### OUTER DRIVE FORCE MAIN CATHODIC PROTECTION

Contract No. BE20-082

**ADDENDUM NO.:** THREE

**September 23, 2019**

**FLANGE CONNECTION**  
**DETAILS**

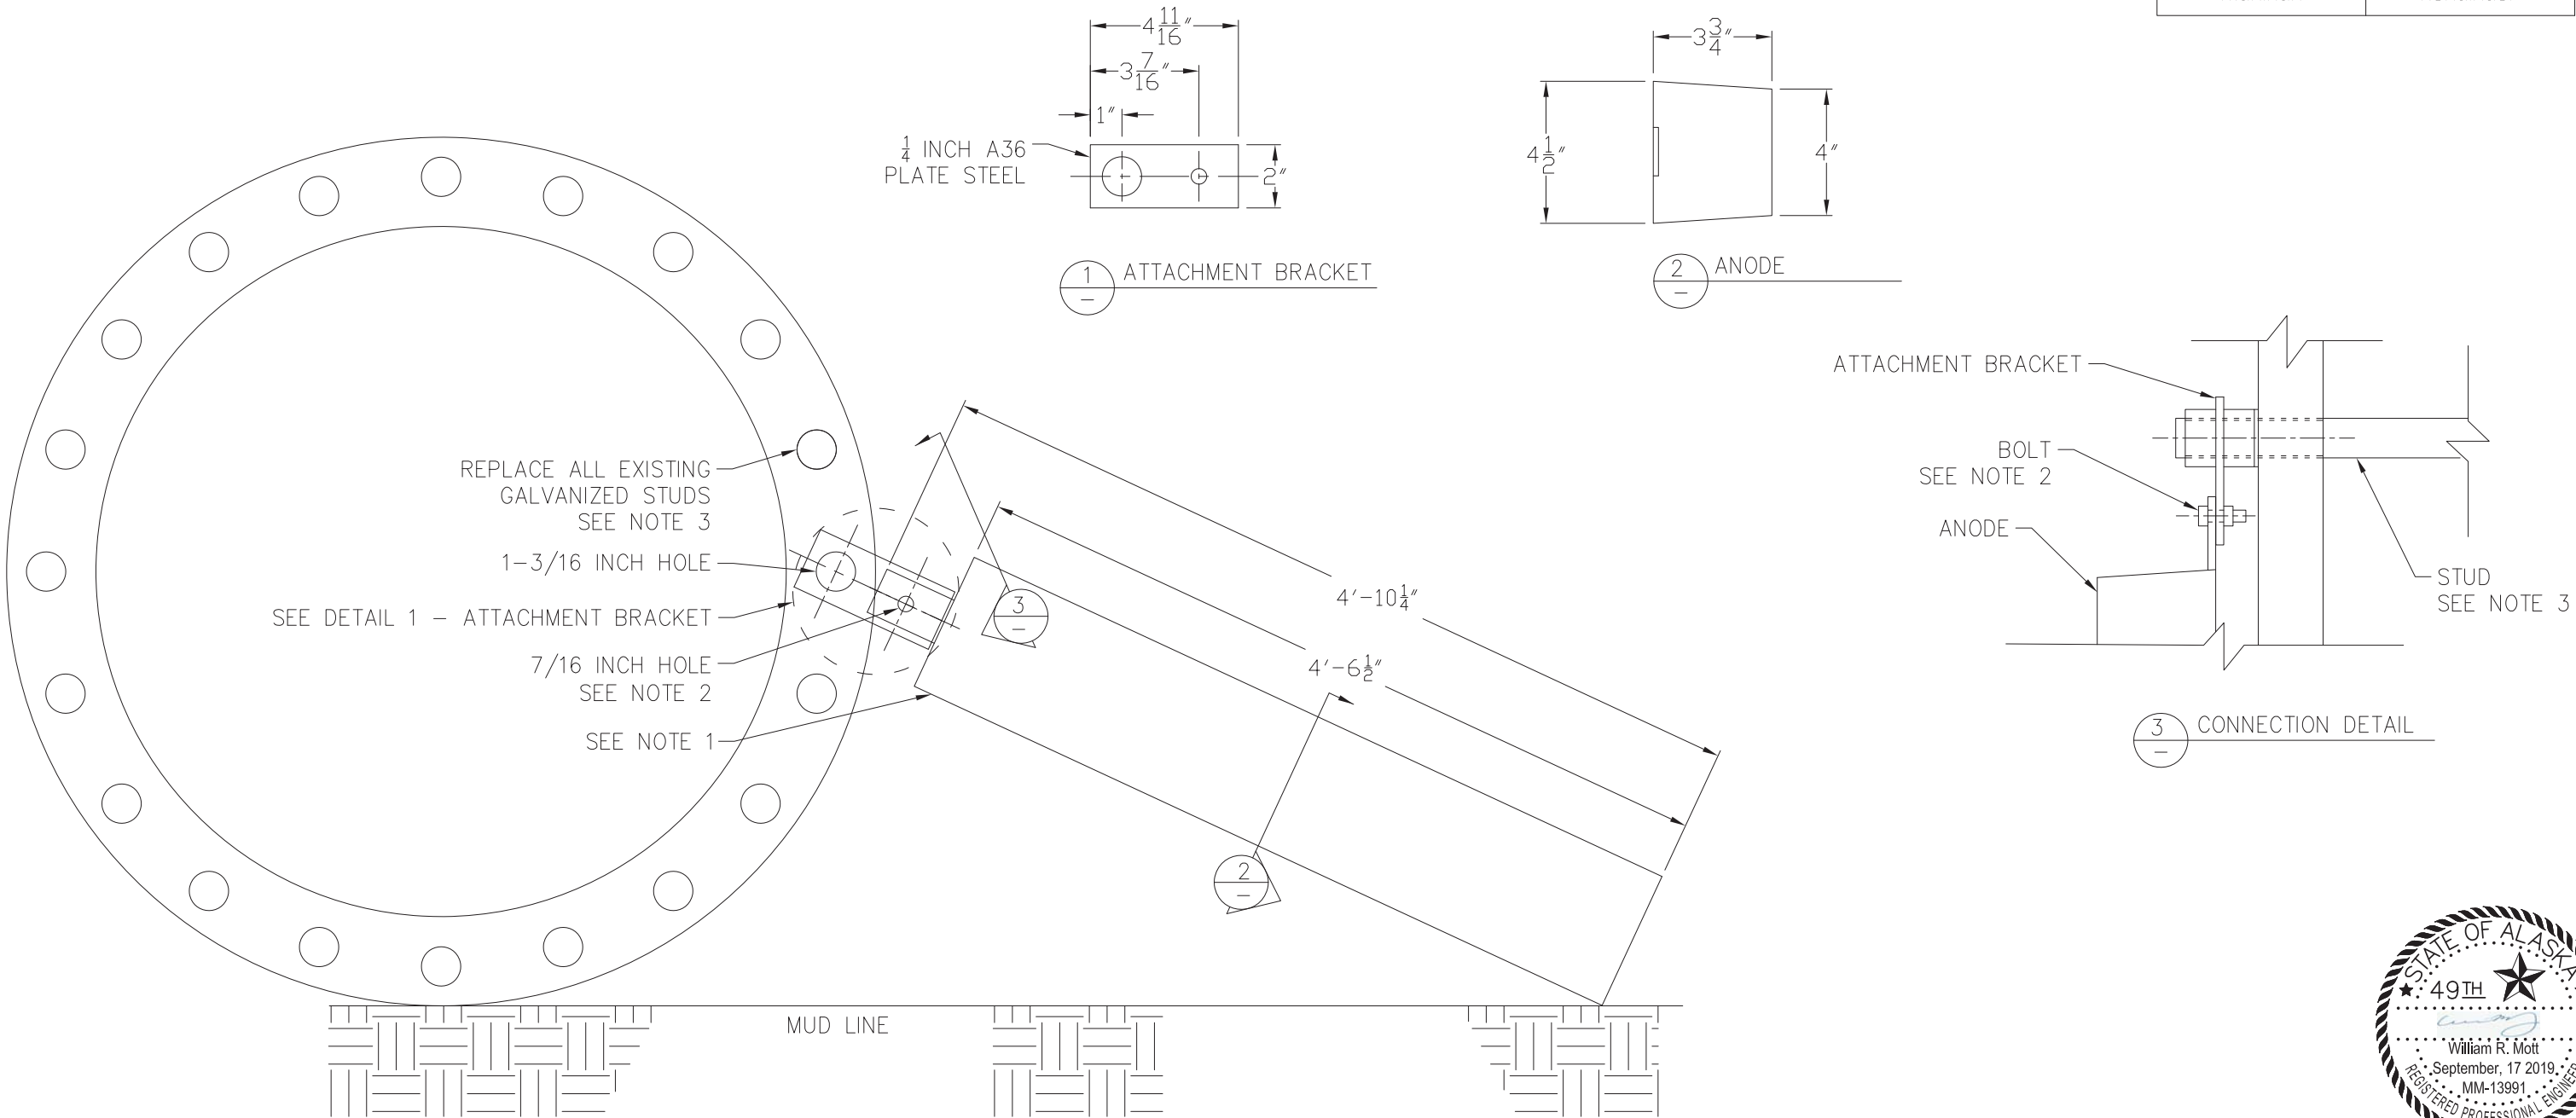
Item No. 1 ***Replace*** SHEET 2 of 4 – FLANGE CONNECTION DETAILS  
***with*** the attached SHEET 2 of 4 – FLANGE CONNECTION DETAILS

STUDS WILL BE 18 INCH X 1-1/8 INCH STAINLESS STEEL A320 GR B8M. NUTS WILL BE A194 GR 8M. WASHER WILL BE 316L. ~~TORQUE TO 424 FT-LBS.~~  
**LUBRICATE STUDS AND TORQUE TO 230 FT-LBS.**
4.
